CITY PLANNING COMMISSION

APPLICATION: A. Negative Declaration
B. Tentative Map (P84-381)
C. Special Permit for construction of 195 condominium units (Sec. 2-B-3a)

PROPOSAL: The applicant is requesting the necessary entitlements to construct 195 airspace condominium units.

APPLC. NO. P84-381

SITE PLAN

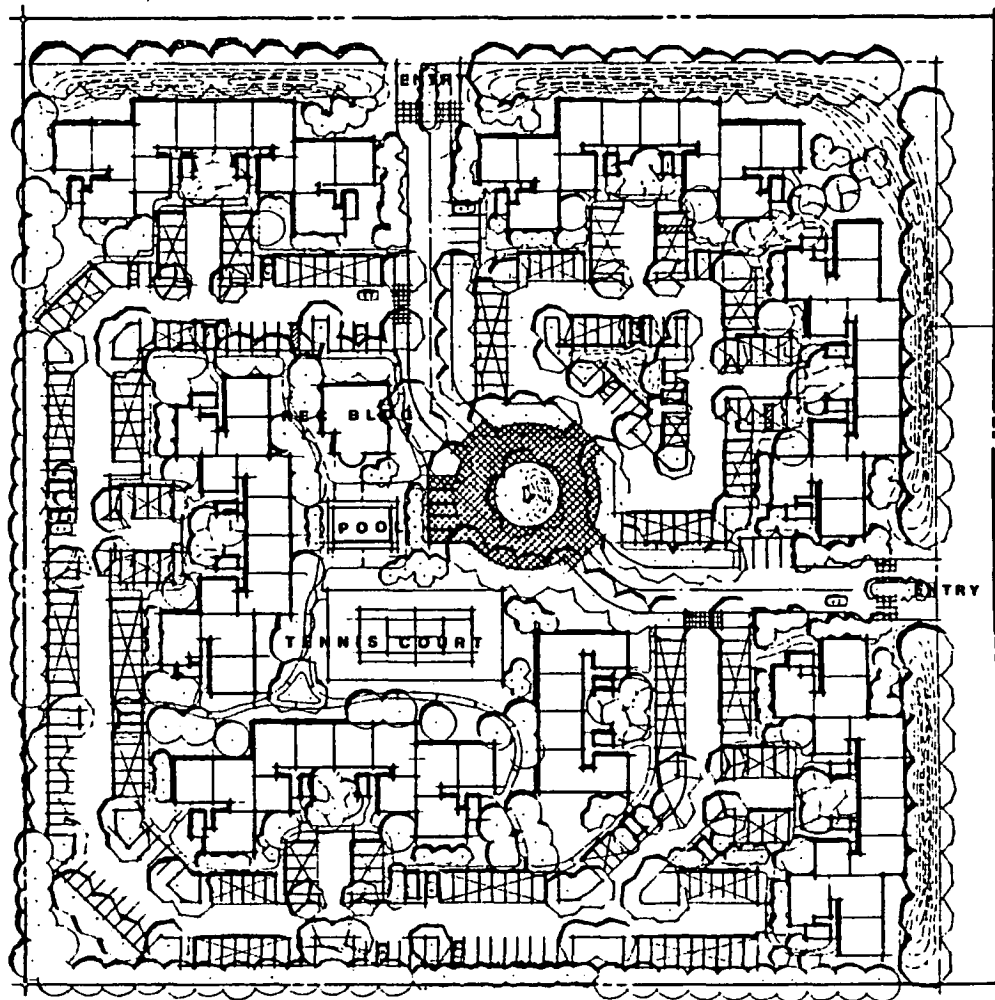
- F. The site plan indicates a centralized outdoor recreational area and building. One covered parking space for each unit and one uncovered space for each two units is proposed. The site plan indicates convenient access from parking to residential units. The applicant should provide access from the interior of the site to the Regional Transit stop to be located on Norwood Avenue. The Traffic Engineer comments that circulation may be awkward in the triangular parking area at the north-east corner of the site. In addition, entrances must be constructed to City standards.

- G. No bike lockers or trash enclosures are indicated on the site plan. These shall be designed according to Exhibits B and C. Plans shall be approved by the Planning Director prior to issuance of building permits.
- H. The Planning and Parks Divisions have determined that parkland in-lieu fees are appropriate. Fees shall be based upon 1.716 acres of land multiplied by the acre value established by the applicant's appraisal.
- I. In conclusion, the applicant has presented a distinctive and attractive environment which will be conducive to individual ownership. Staff supports the special permit and tentative map.

1. The applicant shall revise the plans to open up stairwells in a manner similar to the building walkways. Revised plans shall be reviewed and approved by the Planning staff prior to issuance of building permits.
2. The applicant shall comply with Exhibit A, ~~Multi-Family Security Design Criteria~~ ^{Criteria}. Plans shall be approved by Planning staff prior to issuance of building permits;
3. Plans for bicycle lockers and trash enclosures shall be approved by the Planning staff prior to issuance of building permits; plans shall conform to Ex. A.
4. A path from the interior of the site to the Regional Transit bus shelter shall be provided. Location shall be reviewed by the Planning staff prior to issuance of building permits.

TYPICAL BUILDING PLAN

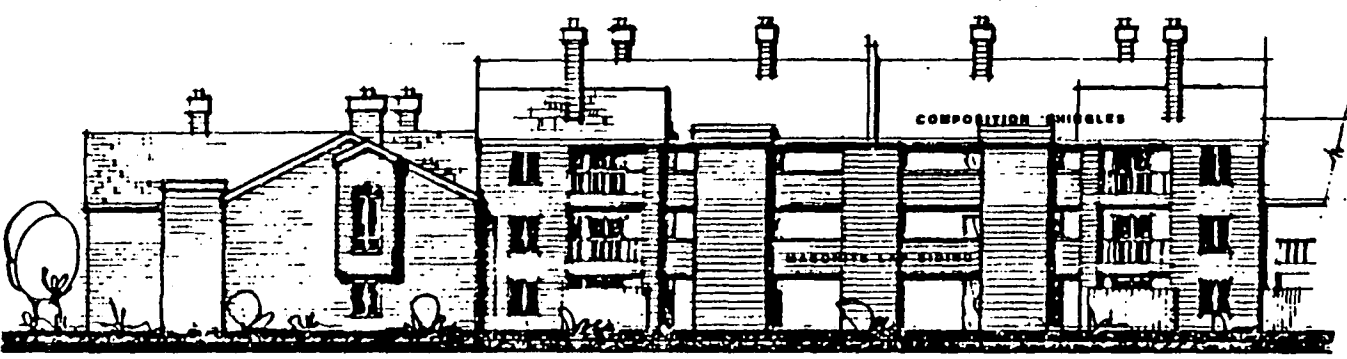
- D. The applicant is proposing 195 airspace condominium units in cluster structures, two and three stories in height. The structures are to be constructed of masonite lap siding with composition roofing material. There is sufficient relief in the elevations to provide visual interest. The applicant has proposed a unique system of access with enclosed stairwells and partially enclosed walkways on each floor. The Police Department has expressed concern regarding the enclosed stairwells. They provide convenient cover for theft or other attack. Staff, therefore, recommends these stairwells be partially opened in a manner similar to the walkways. The applicant should comply with Exhibit A, Personal Safety Criteria, of the Multi-Family Design Criteria.
